Additional demolition - Level 7 slab

Job	65 KINGSWAY	Date	29/07/2020
Title	Revised Planning	Eng.	SO
Job No.	2028	Sheet	0

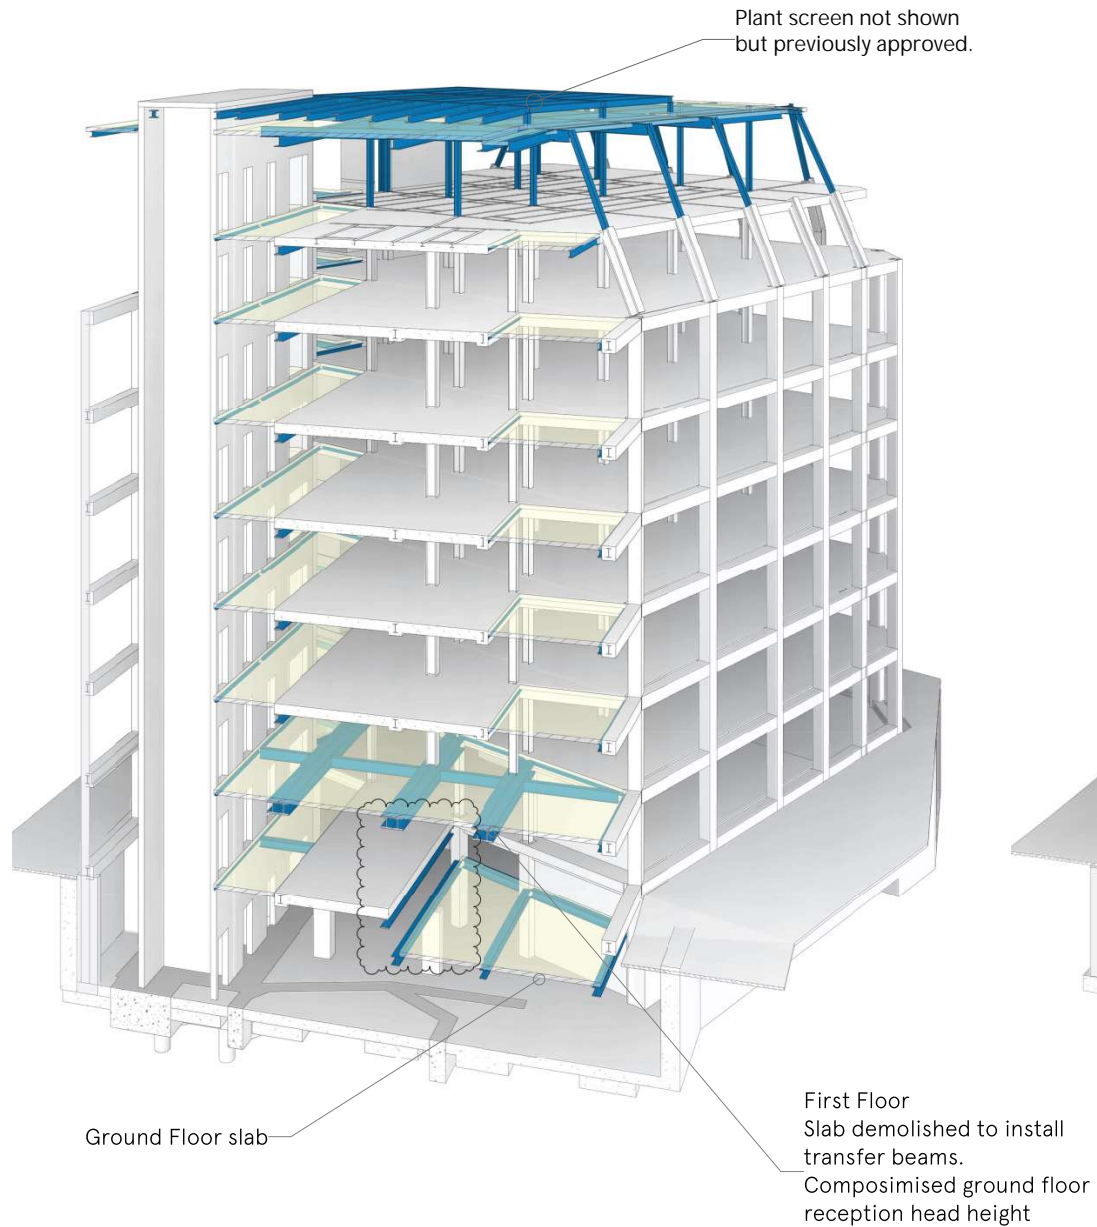
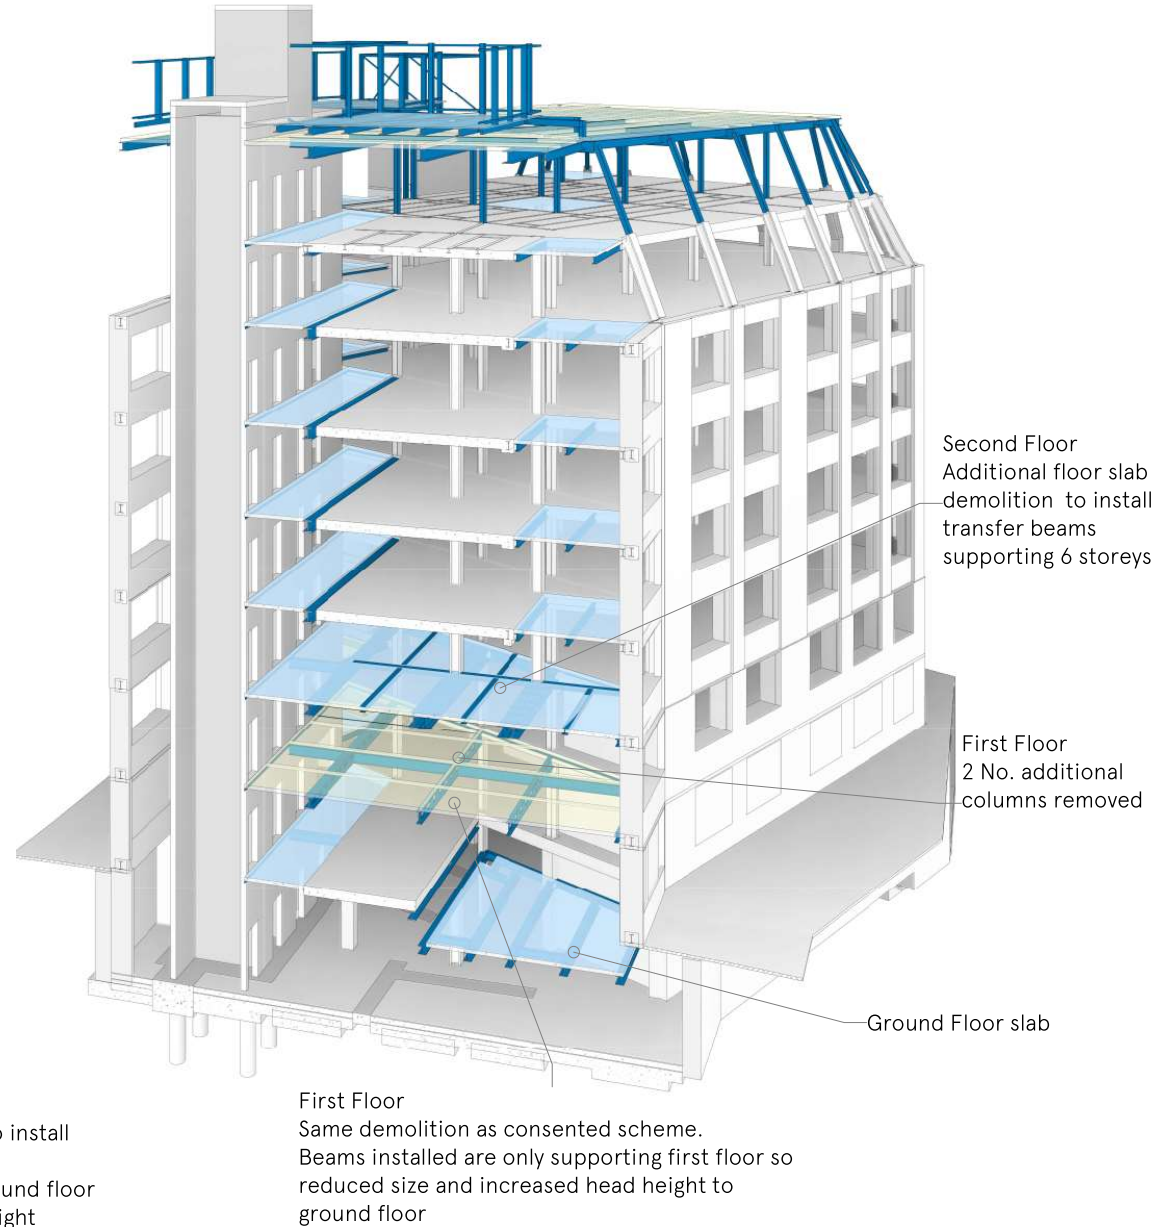
Approved Planning Scheme

Revised Scheme

Site photo of corrosion to existing steel bars

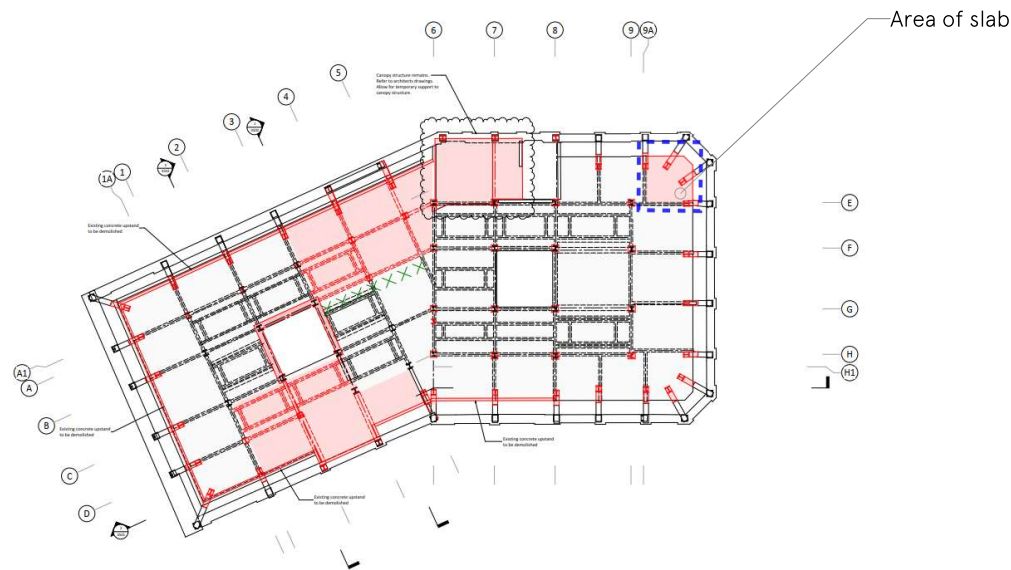
Site photo of condition following soft strip. All loose concrete was removed due to health and safety and to inspect the condition of the remaining slab

Site photo of slab soffit following loose concrete removal.

Many bars have suffered significant corrosion due to suspected water ingress.
